**ADDENDUM NO. 1**

**PALOLO VALLEY HOMES MODERNIZATION, PHASE 3**  
HONOLULU, OAHU, HAWAII  
Tax Map Key No.: (1) 3-004-015

HPHA Job No. 15-016-108-Z  
IFB-CMB-2016-17

May 23, 2016

DEPARTMENT OF HUMAN SERVICES  
 PALO ALTO VALLEY HOMES MODERNIZATION PHASE 3  
 (BUILDING 10 & 11)  
 ENGINEER: [Signature]  
 PROJECT NO.: 10-10-10-3  
 SHEET NO.: C-301  
 DATE: 10/10/10

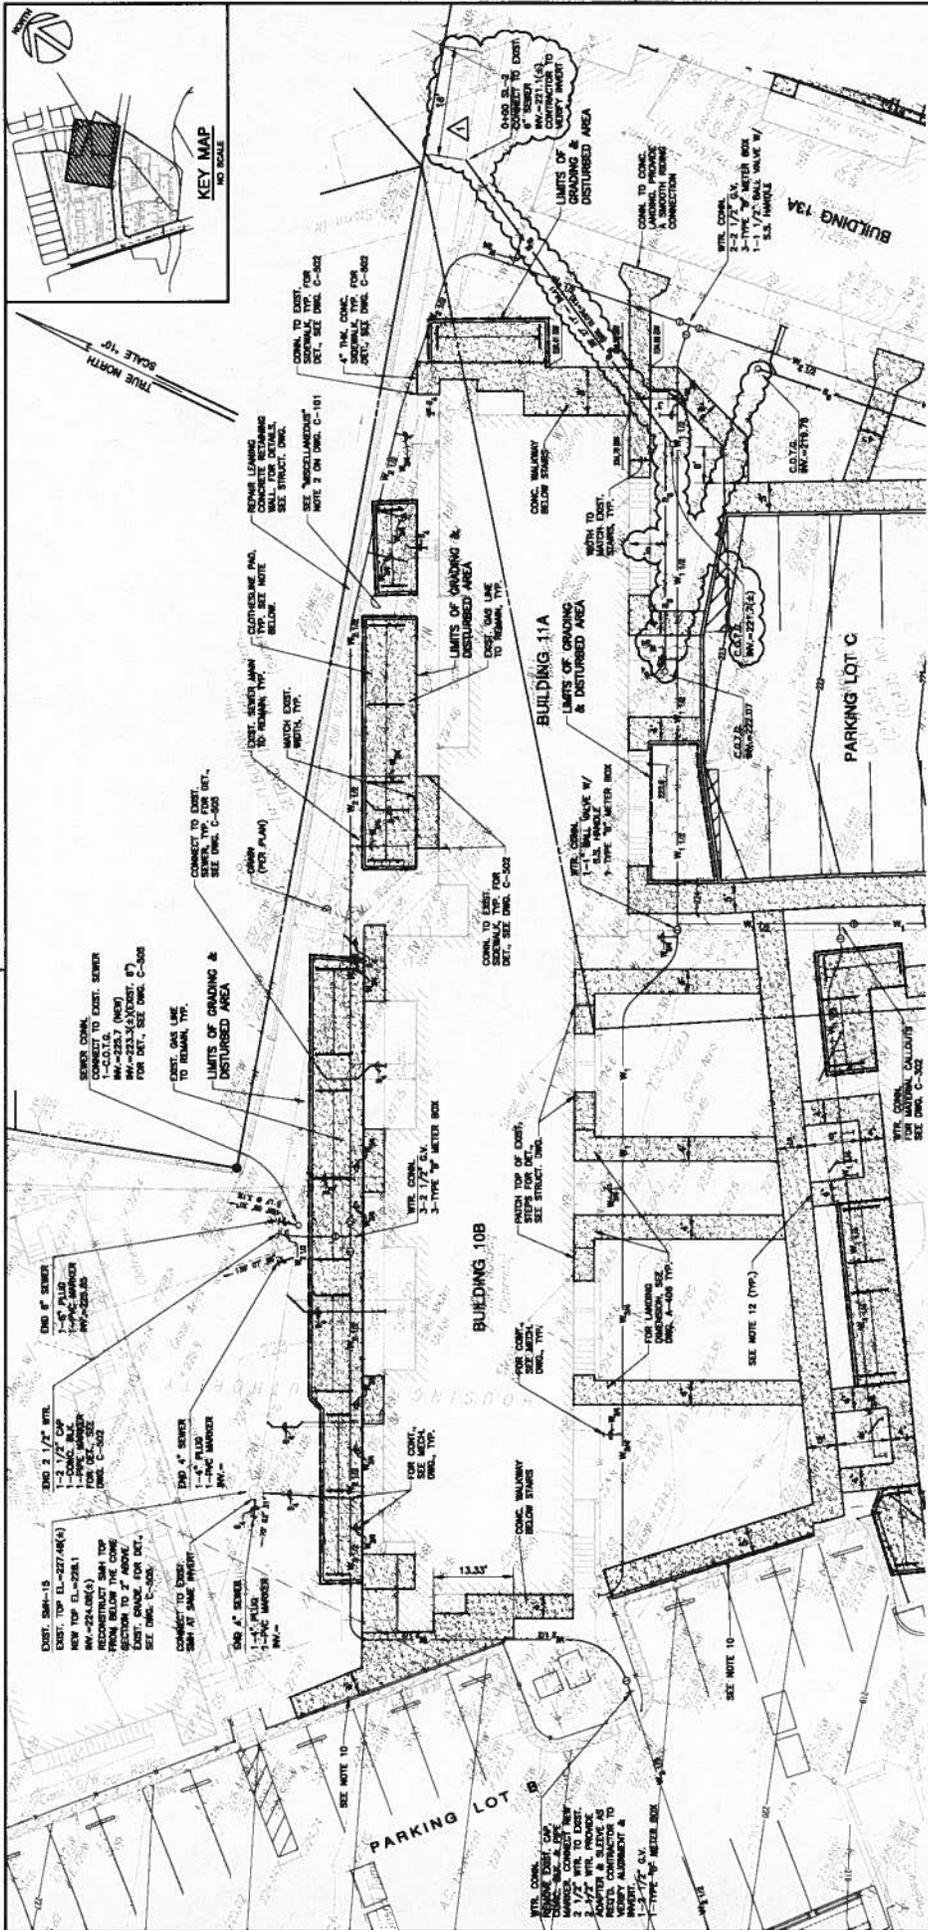
- A. The following drawing sheets have been revised and marked Rev. 1 dated 5/19/16 (see attached). The revised sheet shall supersede the original liked plan sheet (general descriptions are noted hereinafter):
  - 1. Drawing No. C-301
    - a. Revised sewer alignment for Building 11A.
    - b. Revised Note.
  - 2. Drawing No. C-302
    - b. Added Notes and callouts.
  - 3. Drawing No. C-303
    - a. Revised sewer alignment for Building 11A.
    - b. Revised sewer lateral size for Building 13 within City sewer easement
    - c. Added COTG to Building 13 sewer lateral outside of City sewer easement.
    - d. Added note and callout.
  - 4. Drawing No. A-101
    - a. Revised notes.
  - 5. Drawing No. A-102
    - a. Added note.
  - 6. Drawing No. A-103
    - a. Revised notes.
  - 7. Drawing No. A-104
    - a. Added note.
  - 8. Drawing No. A-105
    - a. Revised notes.

DEPARTMENT OF HUMAN SERVICES  
 PALO ALTO VALLEY HOMES MODERNIZATION PHASE 3  
 SHEET NO. 15-016-10B-2  
 A-107  
 05-06-16  
 SCALE AS INDICATED

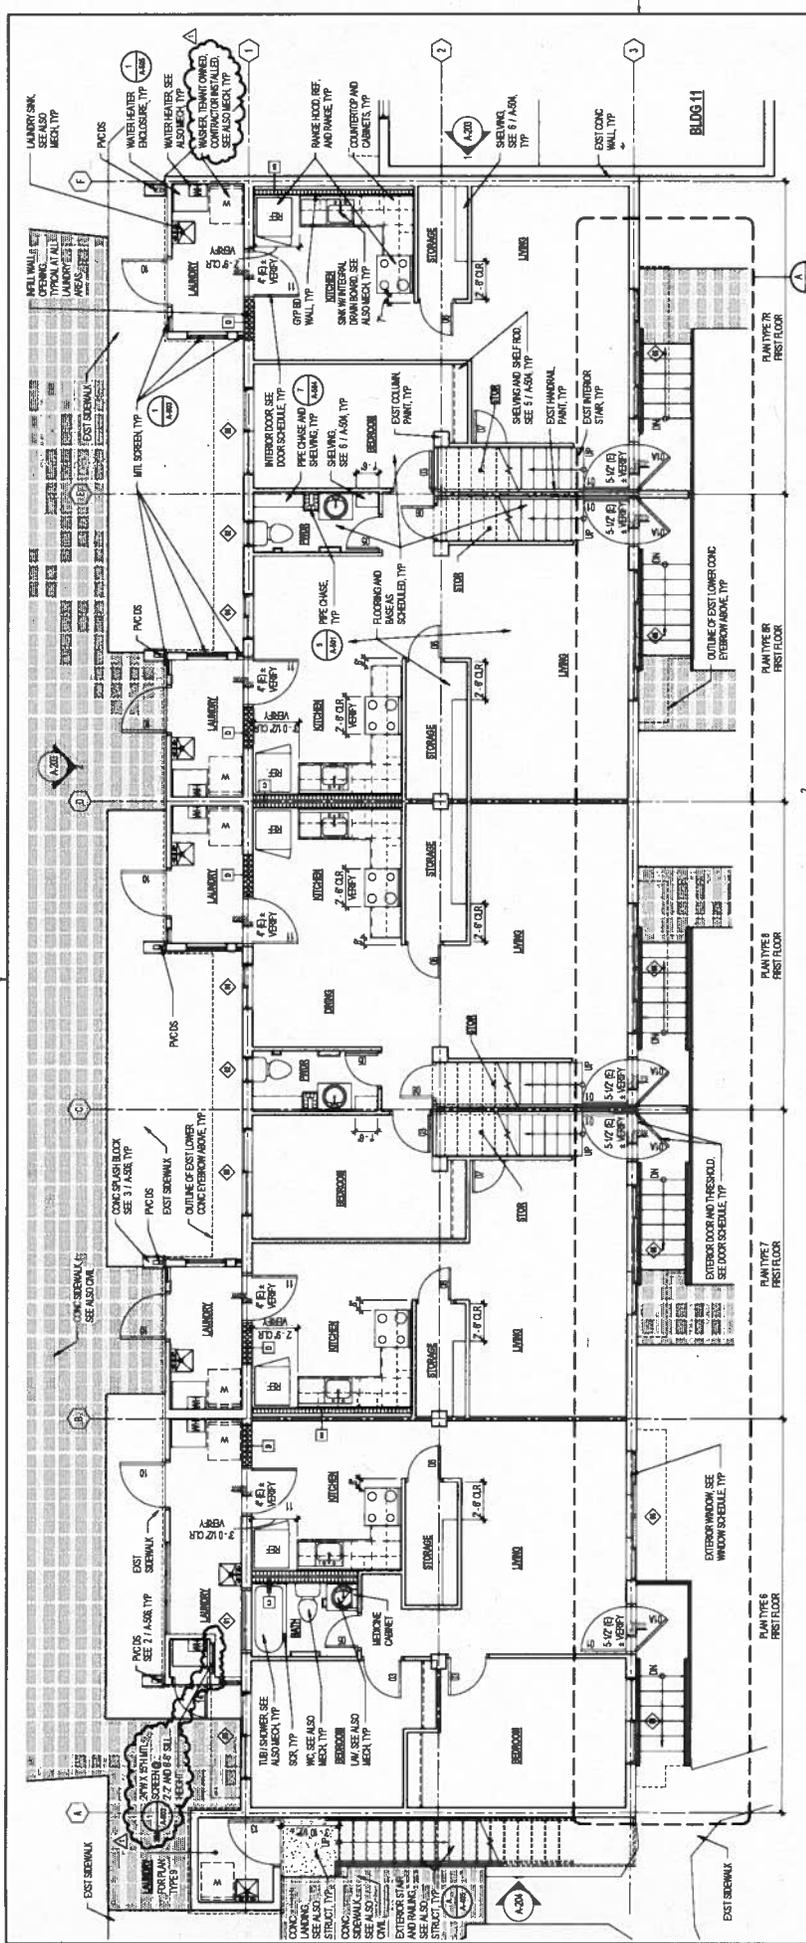
9. Drawing No. A-107
  - a. Revised notes.
10. Drawing No. A-503
  - a. Revised note.
